Re: Petition 1286: West Brookfield Reliability Project
Development and Management Plan Amendment

Drainage Feature Modifications

WEST BROOKFIELD 14H
STORMWATER & EROSION CONTROL DETAILS
CIVIL PLAN & DETAILS
BROOKFIELD, CT

PL-01

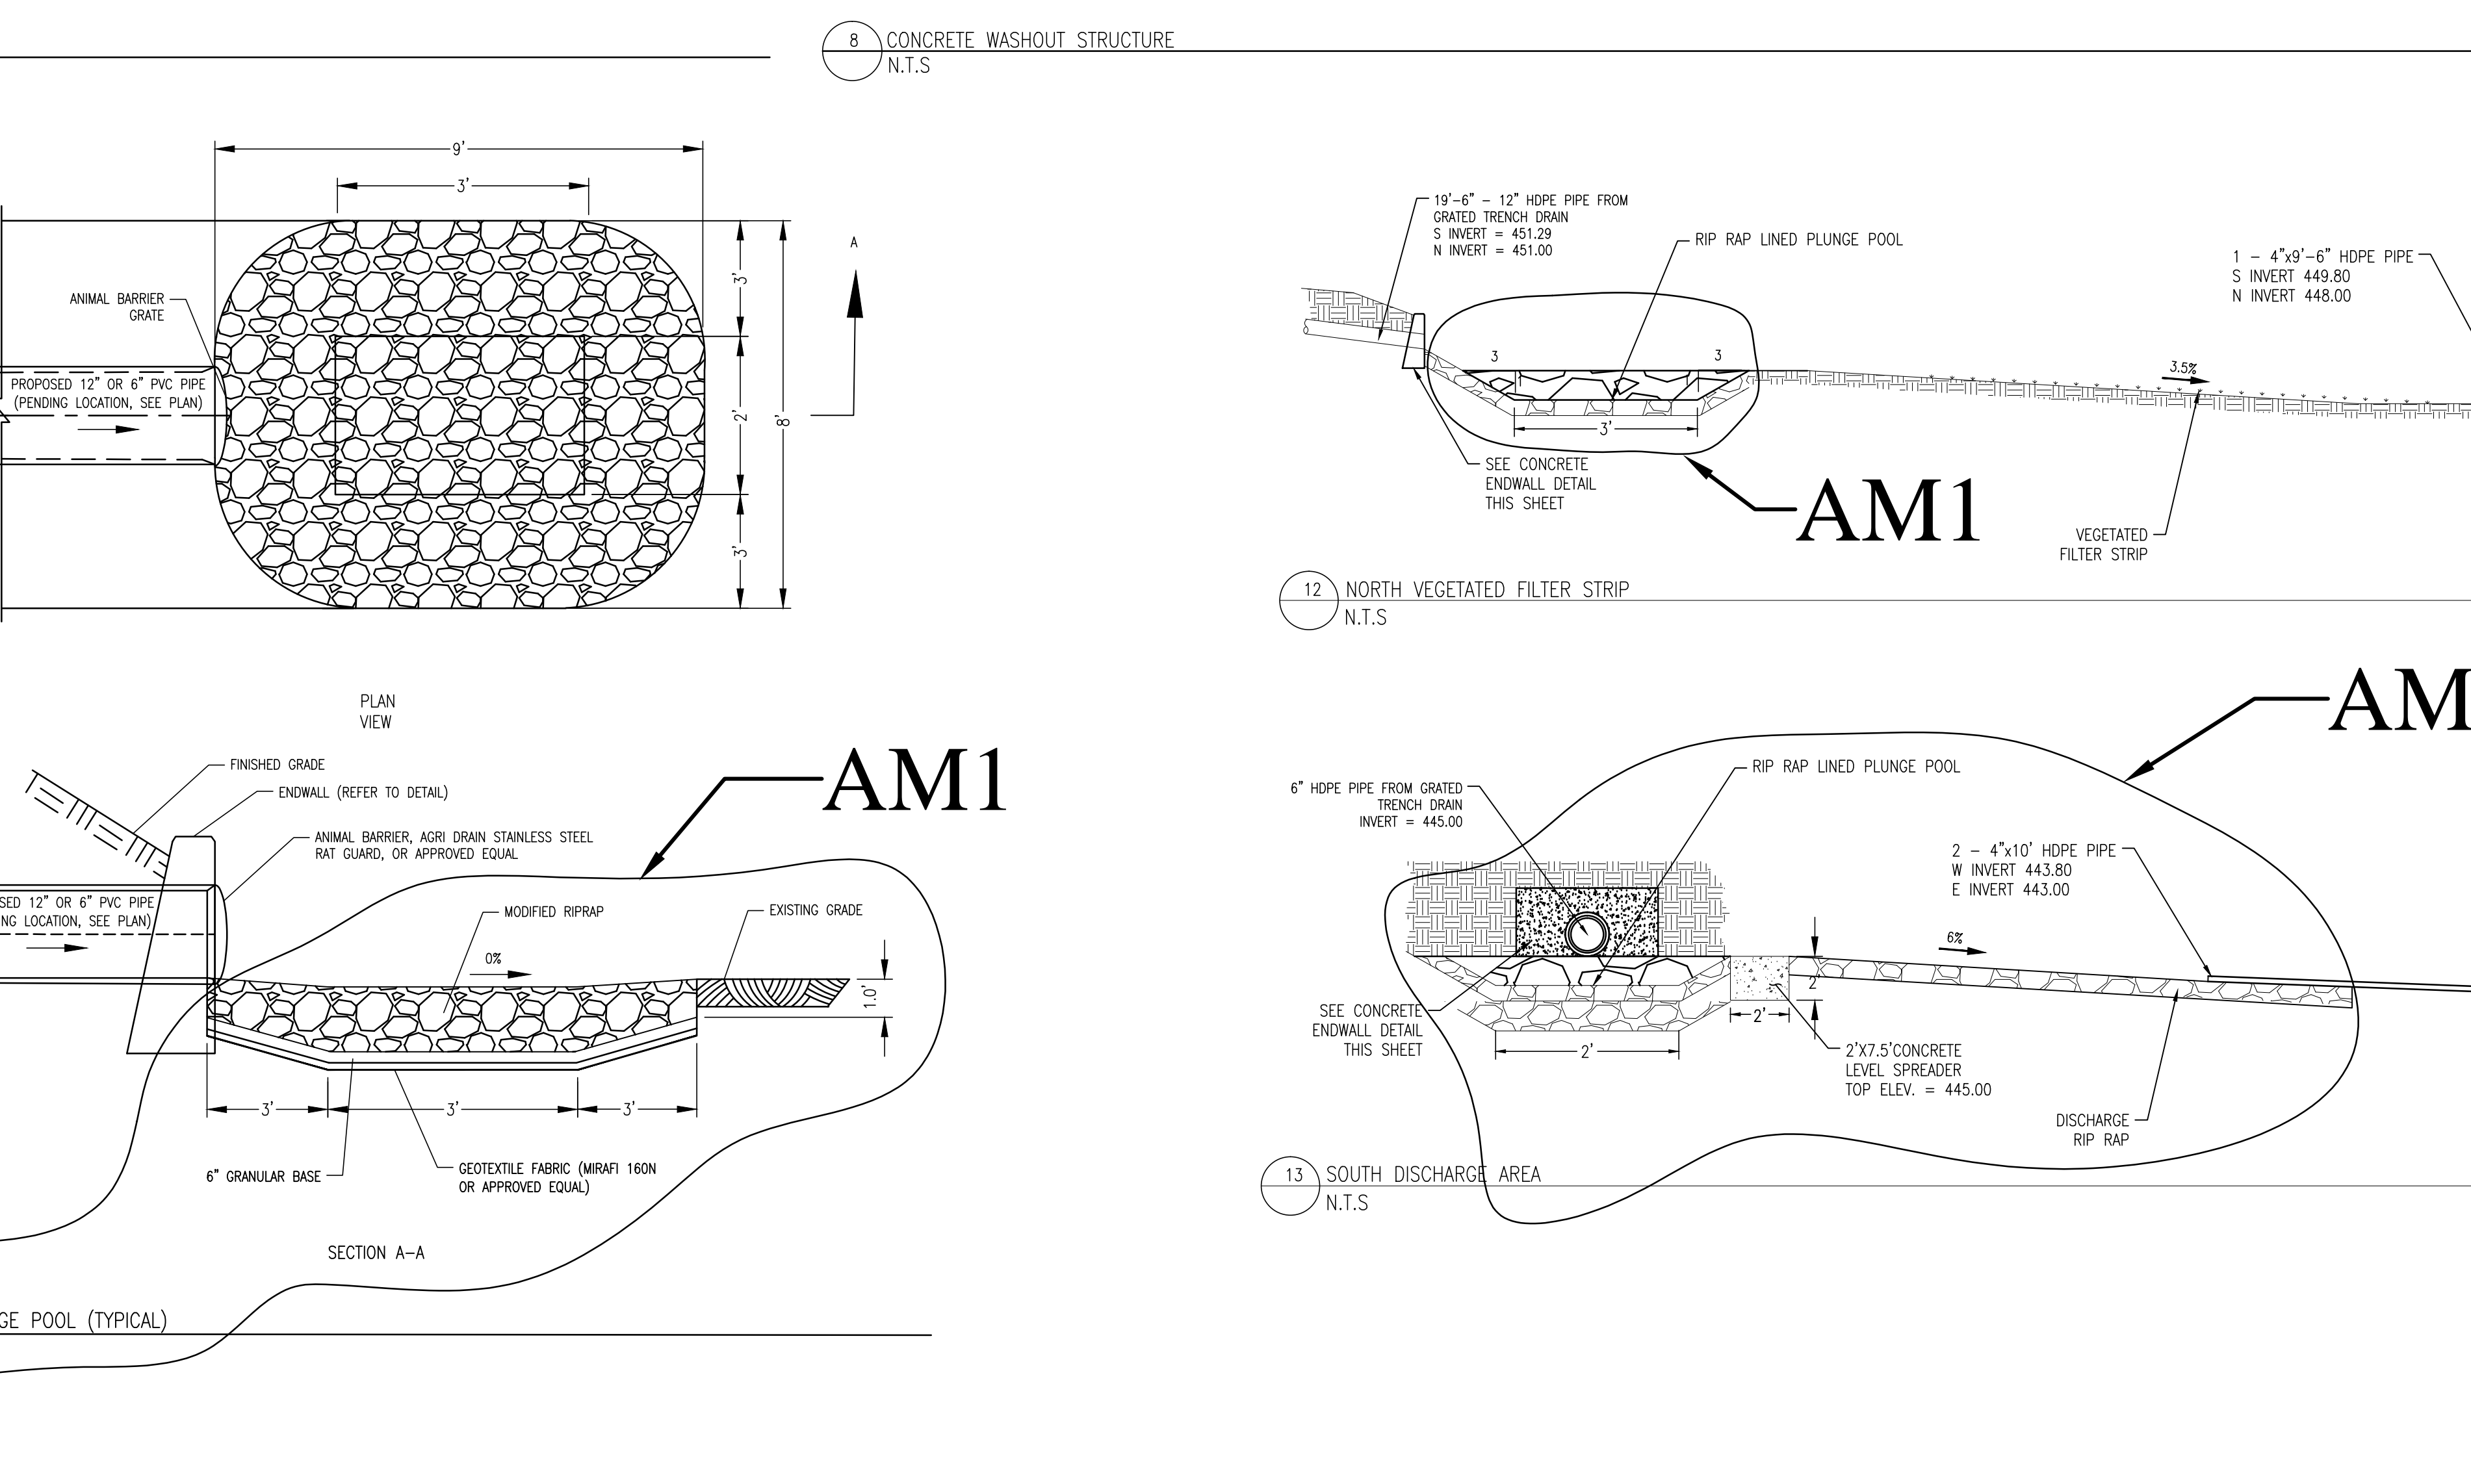
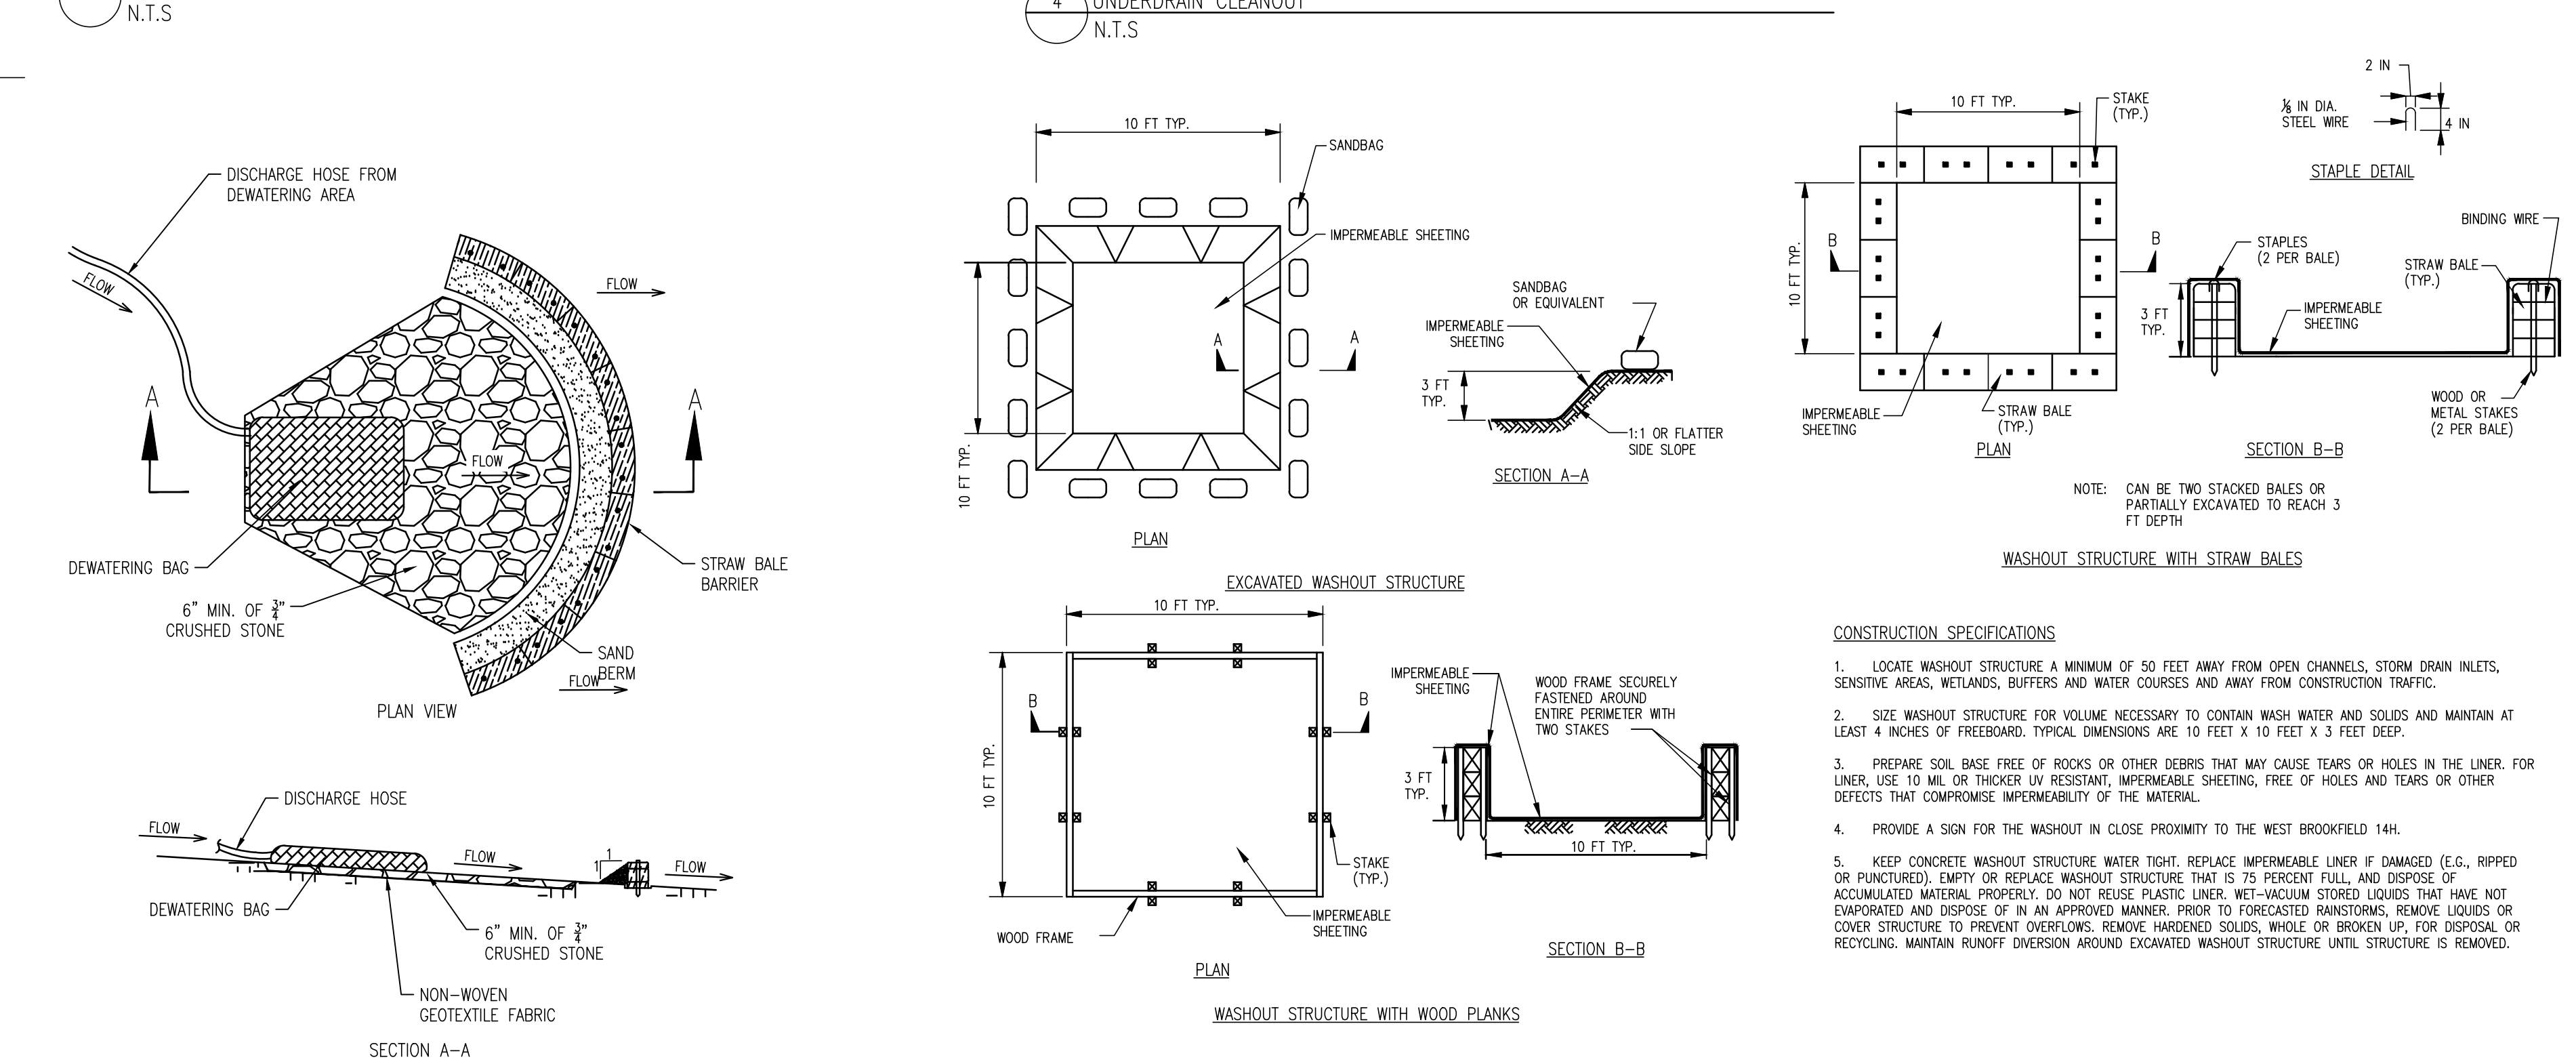
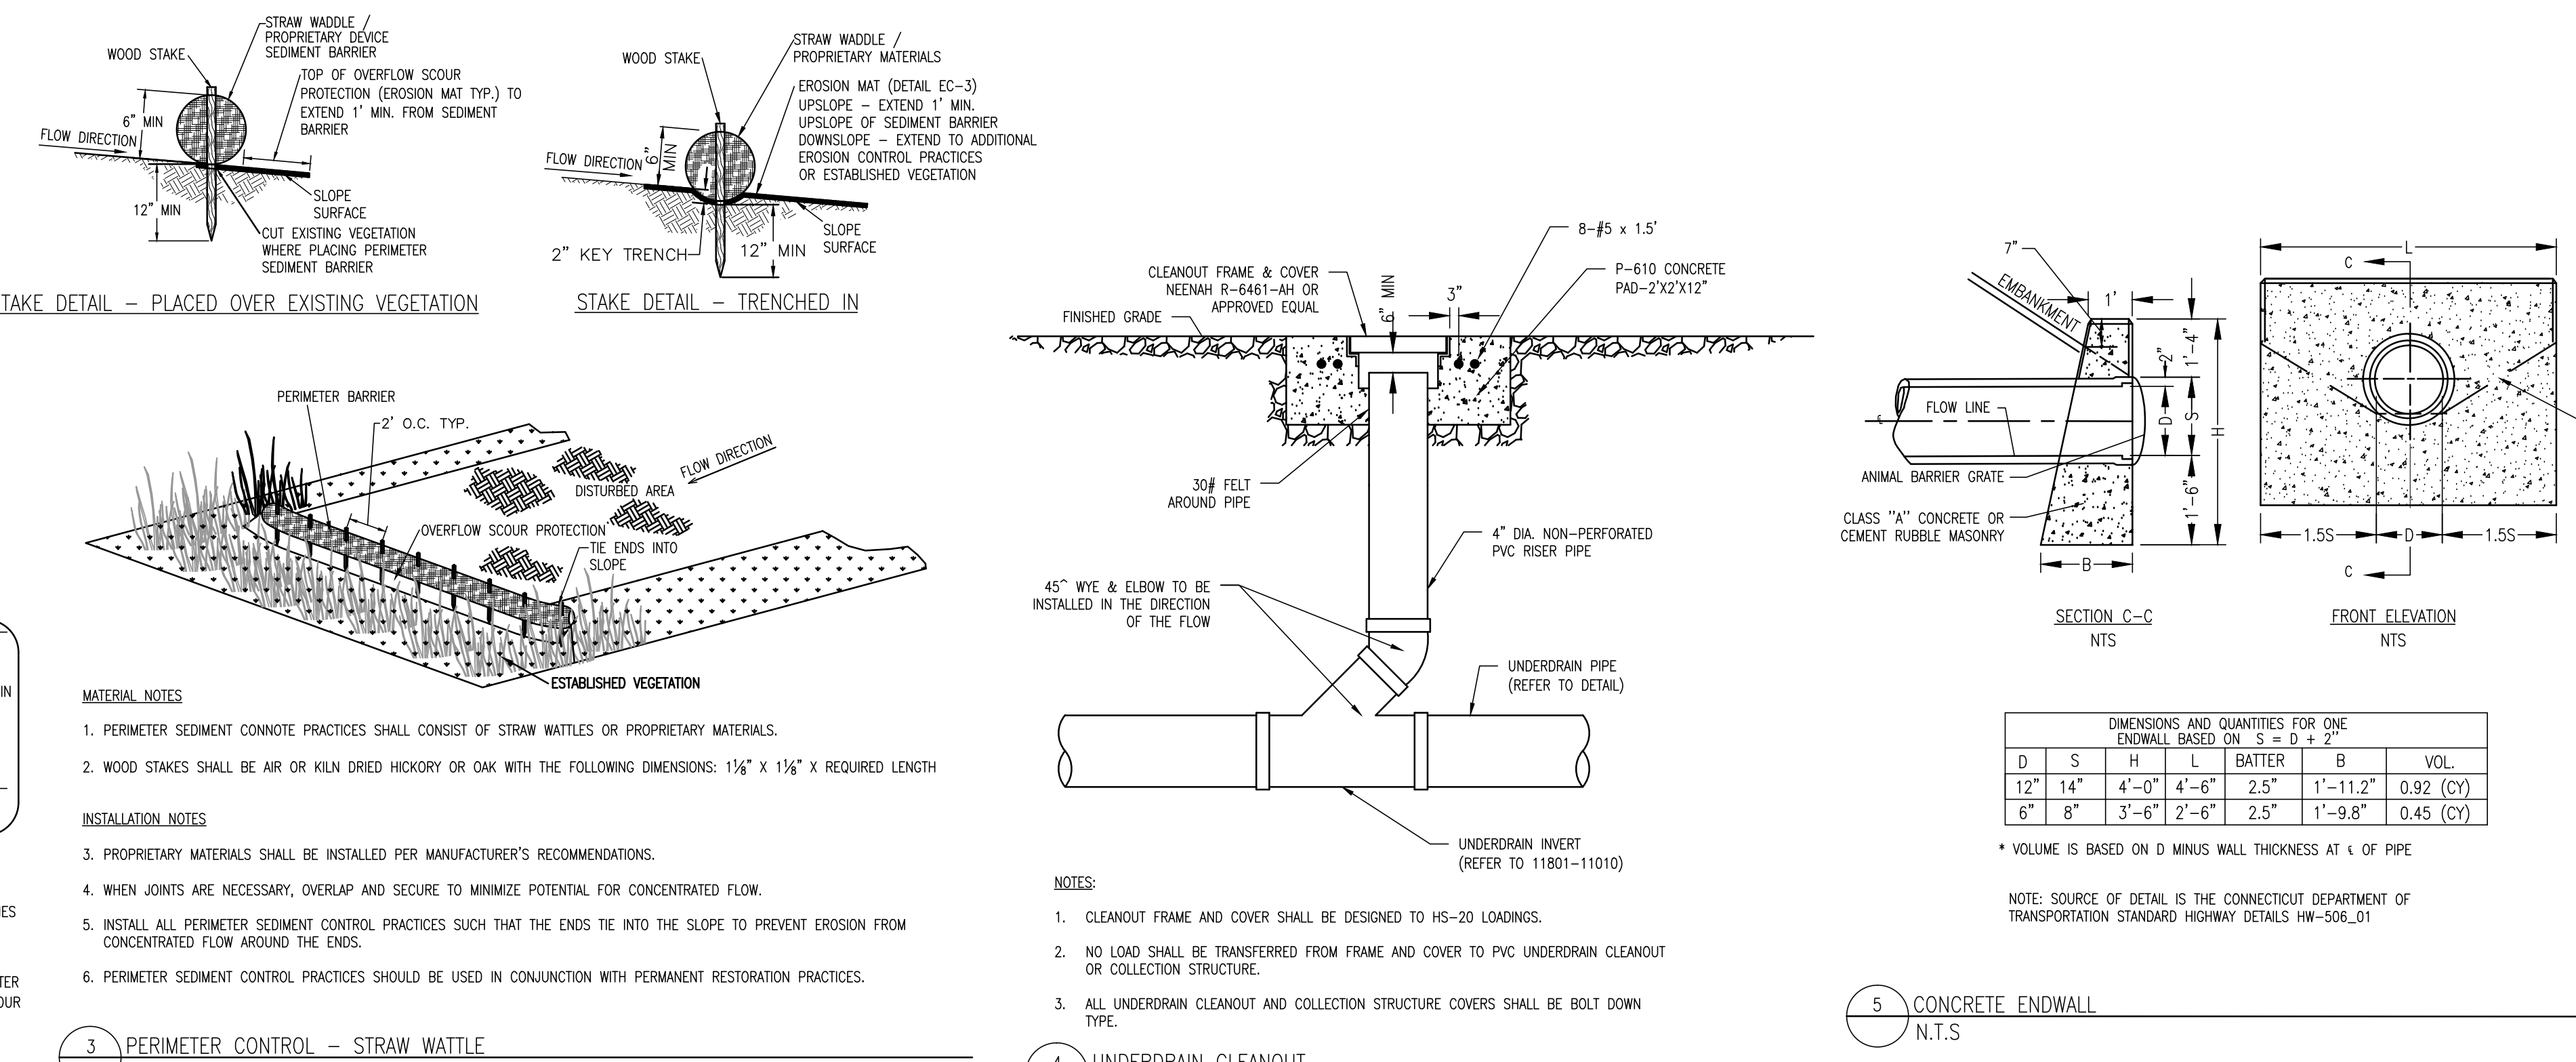
Subsequent to the Council’s approval of the D&M Plan, Eversource’s continued discussions with the property owner located to the west of the expanded substation. As a result, the abutter expressed a preference for plantings on their own property and agreed that this accommodation negated the need for additional plantings on the substation property that were intended to act as a buffer between the substation facility and this property owner (the approved plantings are identified as those with red clouds around them on the attached Visual Mitigation Landscape Planning plan). Eversource now proposes that the approved landscaping plan be modified to limit the plantings on Eversource property to the southwest corner of the entrance to the substation, which will be installed as proposed.

**DELETIONS FROM LANDSCAPE PLANTING PLAN**
